EAST CENTRAL RAILWAY

ARA JUNCTION (ARA JN.)STATION.

PROVISION OF ADDITIONAL HIGH LEVEL PLATFORM WITH CONNECTIVITY TO FOB, PIT LINE WITH CAT WALK, SICK LINE, SOUTH SIDE CIRCULATING AREA & STN. BLDG. AT ARA JN. STN.

SCALE- 1:1000
DRM DNR PLAN NO:- 85-2019
SHEET NO-REVISION-01

ALT-I AS PER CRS'S/ KOL LETTER NO:- CRS/ECR/DNR/ARA/EI/21/1051, DATED-11/10/2021.

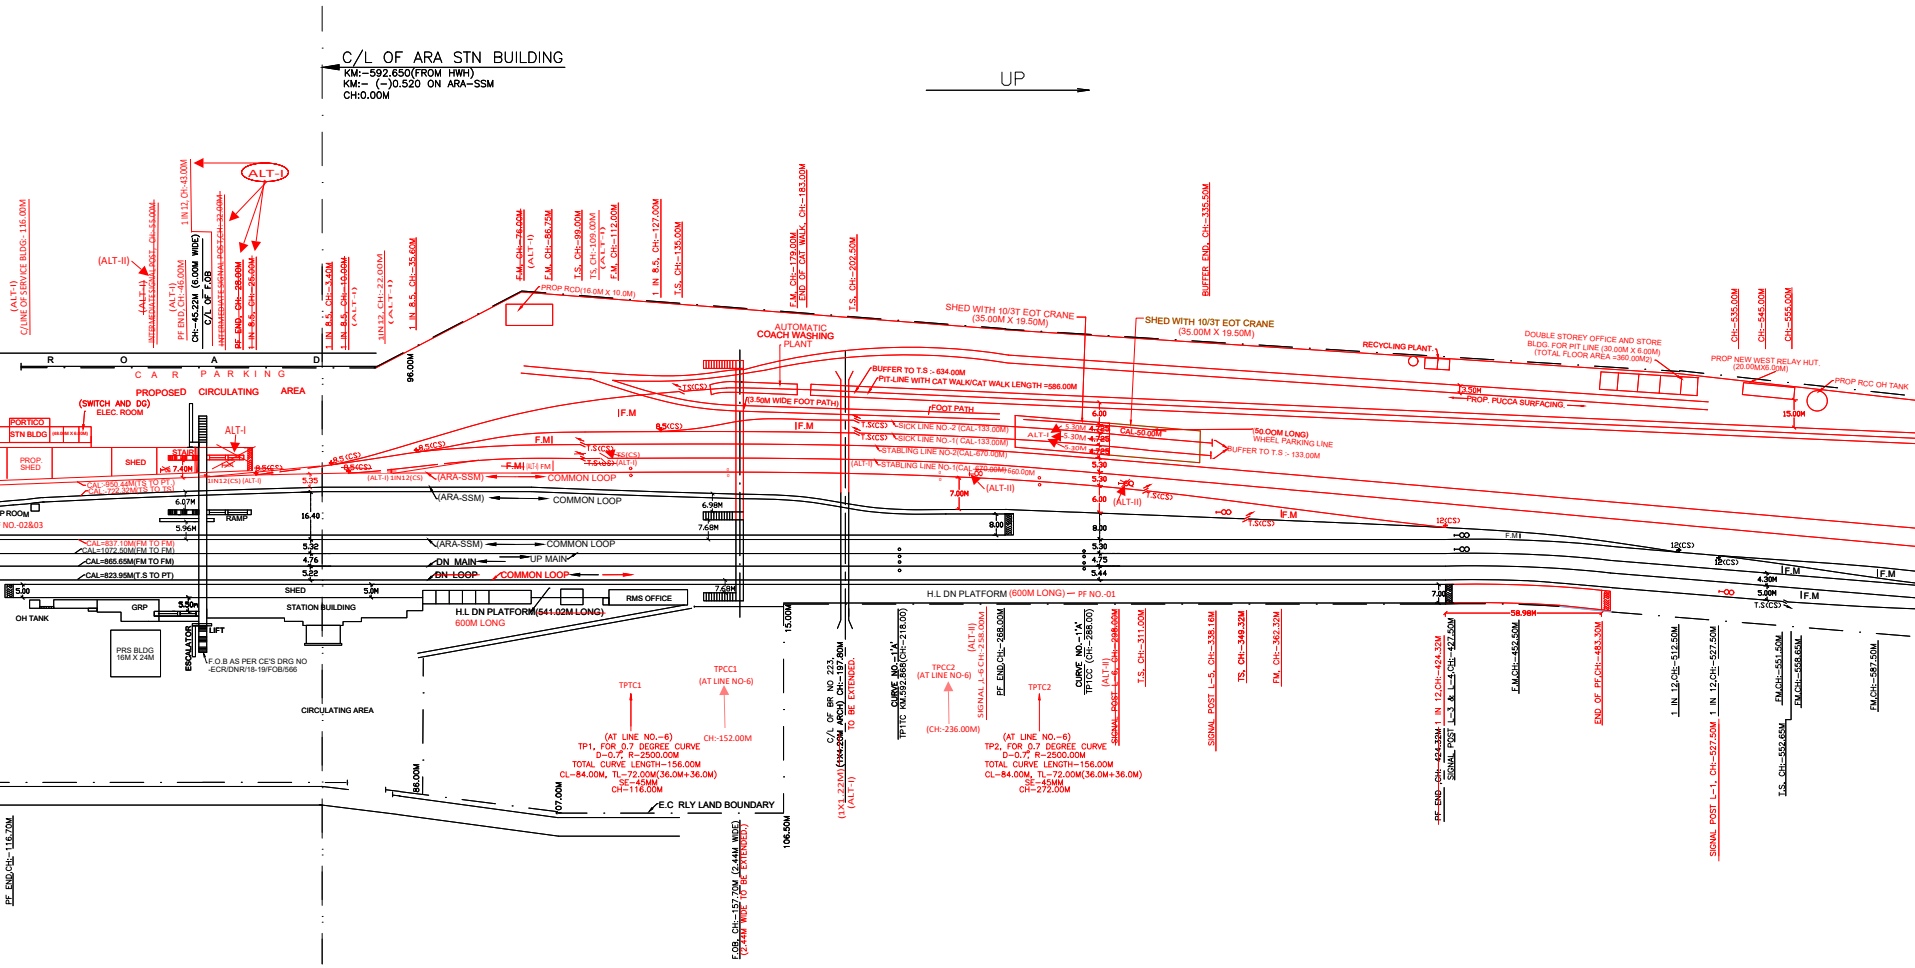
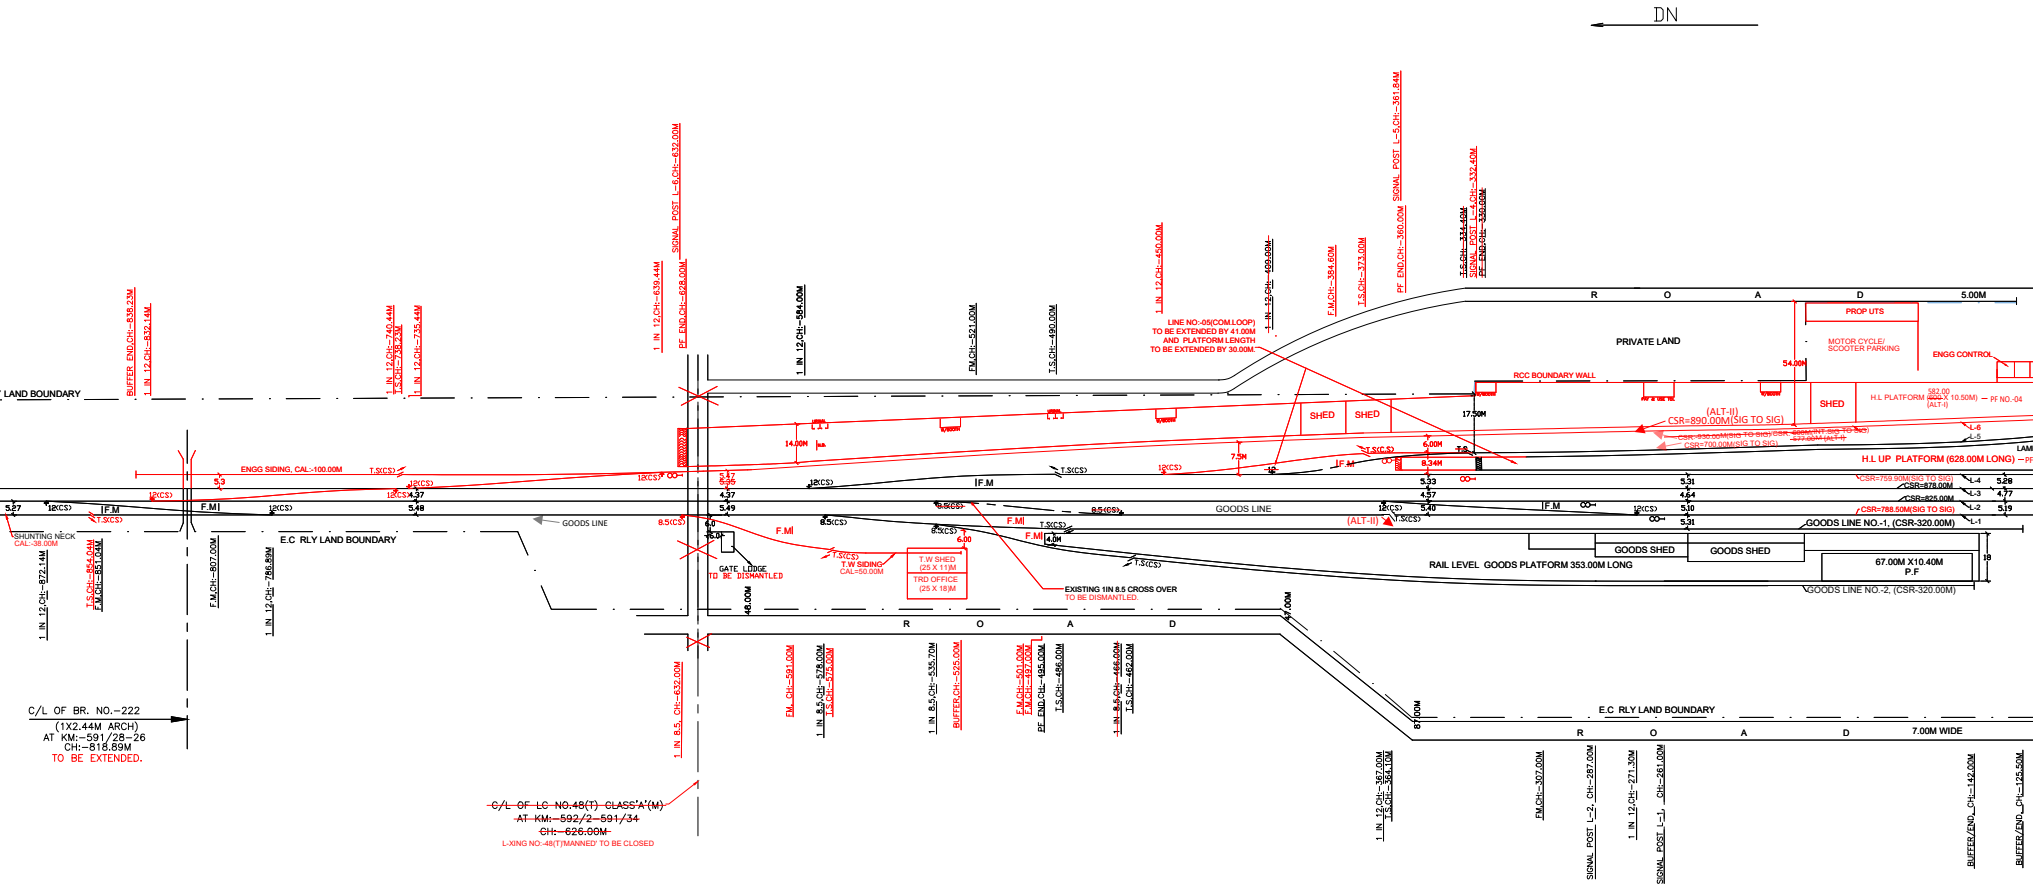
COMPLIANCE OF OBSERVATIONS VIDE LETTER NO. CRS's/KOL LETTER NO:-CRS/ECR/DNR/ARA/EI/21/1051 , DT:-11/10/2021

FOLLOWING DETAILS HAVE BEEN INCORPORATED IN THE ESP i.e STATION NAME IN HINDI, STATION CODE, TYPE OF ROUTE, FULL NAME OF NEXT BLOCK STATION KUA AT HWH/END, TRACK DETAILS AT LEAST UP TO 2.5 KM FROM THE OUTERMOST POINTS ON EITHER END, DETAILS OF CURVE WITH THEIR TPTC & TPCC, TAKING OFF CLEARING THE FM OF THE FORMER ONE TO AVOID SIDE COLLISION, FL OF ALL GRADIENTS, SHIFTING OF NEW CROSS OVER AT HWH/END TO AVOID INFRINGEMENT WITH EXISTING GRADIENT, SHIFTING OF THE TS FROM CH.-386.00M(PREVIOUSLY APPROVED) TO CH.-349.32M AND FM FROM CH.-355.60M(PREVIOUSLY APPROVED) TO CH.-362.32M IN LINE NO.5 AT DLI/END FOR PROTECTING THE RESPECTIVE FM, FM FOR ALL TURN OUTS, LATEST TVU OF THE LCs ALONG WITH THIER CLASSIFICATION, DELETION OF LC NO.48, TABLE REGARDING INFRINGEMENT DETAILS.

THE DETAILED NOTES (SL. NO. - 14 TO 17) INCORPORATING IN THE ESP REGARDING NON COMPLIANCE OF 1 IN 1200 RECOMMENDED YARD GRADIENT, NON REPLACEMENT OF 1 IN 8.5 TO BE 1 IN 12 FOR GOODS LINE NO.-1 AND PROPOSED TW SHED, CORRECTION OF THE SIDE OF DERAILMENT OF THE T.S AT CH.-364.10M , FACILITIES PROVIDED OF AN ENGINEERING SIDING AND A SHUNTING NECK IN LIEU OF SAND HUMP AT HWH/END.

1. TRACK CENTRE BETWEEN STAB.LINE NO.-2,SICK LINE NO.-1, SICK LINE NO.-2 AND WHEEL PARKING LINE HAVE BEEN CHANGED BY 5.30M IN LIEU OF 4.725M.
2. 1IN8.5 T/Os TO BE REPLACED BY 1IN12 T/Os AT CH:- 22.00M AND 43.00M IN LIEU OF PREVIOUS APPROVED CH:- 10.00M AND 25.00M RESPECTIVELY.
3. CHAINAGE OF PF END OF PROPOSED PF NO.-04 AND LENGTH OF PF NO.-04 HAVE BEEN CHANGED.
4. CHAINAGE OF INTERMEDIATE SIGNAL POST OF L-6 AND CSR OF L-6 HAVE BEEN CHANGED.
5. CHAINAGE OF TS, FM AS WELL AS CAL OF STABLING LINE NO.-1 HAVE BEEN CHANGED.
6. CHAINAGE OF SERVICE BUILDING AT SOUTH SIDE CIRCULATING AREA HAS BEEN SHOWN.
7. CLEAR SPAN OF BRIDGE NO.- 223 HAS BEEN CORRECTED.
8. LATEST TVU OF L-XING NO.-6 IN ARA-SSM SECTION HAS BEEN SHOWN.

ALT-II (AUTHORITY:- 1. SR DSTE LETTER NO.-SG/DRG/DNR, DATED-07.03.2022.
2. CRS'S/KOL LETTER NO.-CRS/ECR/DNR/ARA/EI/21/1051, DATED-11/10/2021.

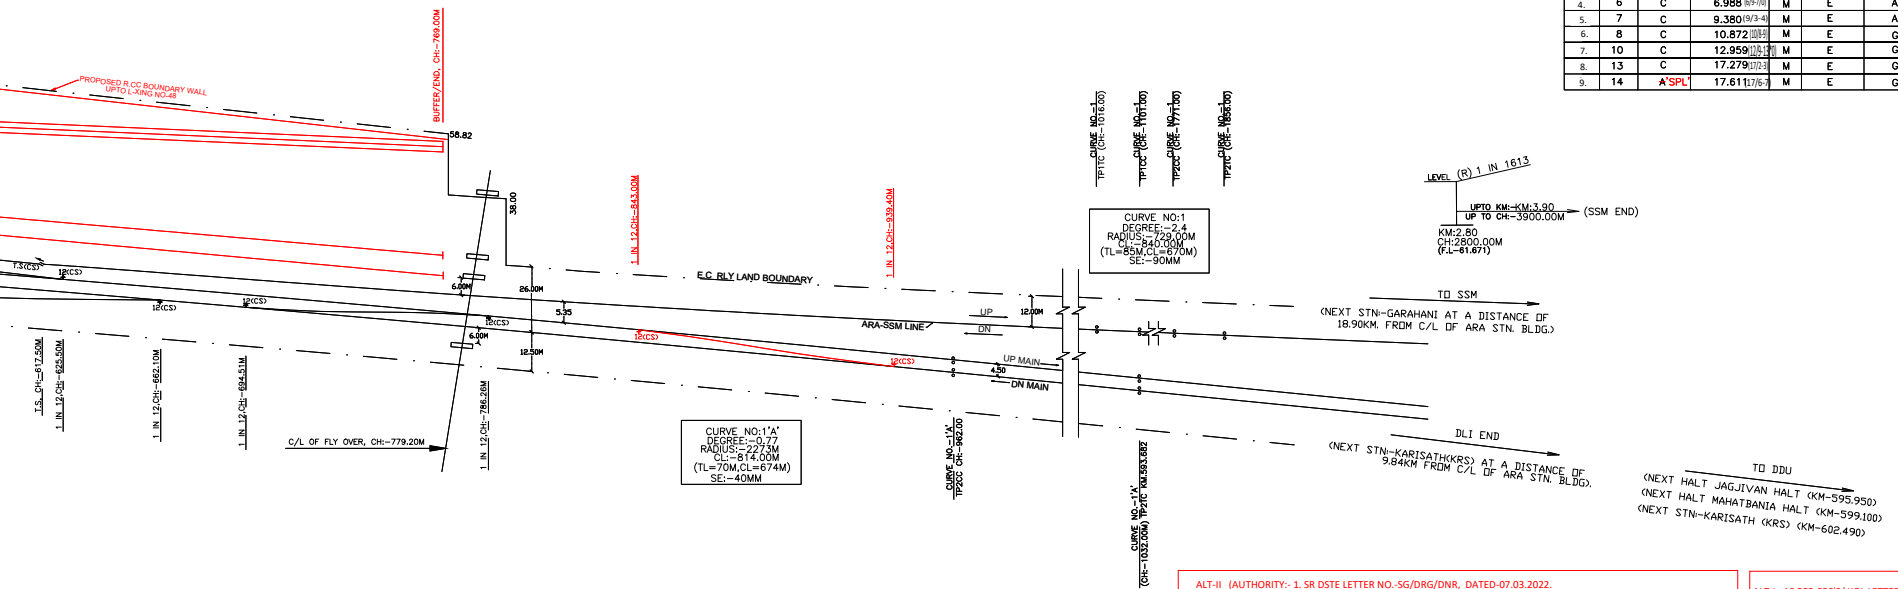
1. INTERMEDIATE SIGNAL PROPOSED AT CH:-55.00M OF LINE NO.-6 TO BE REMOVED AND CSR OF LINE NO.-6 HAS BEEN CORRECTED ACCORDINGLY AS 890.00M.
2. DETAILS OF L-XING GATE WITH LATEST TVU AND CLASS, HAVE BEEN CORRECTED OF ARA-SSM SECTION.
3. DIRECTION OF DERAILMENT SIDE OF EXISTING T.S AT CHAINAGE- 364.10M HAS BEEN CORRECTED AS PER SITE.
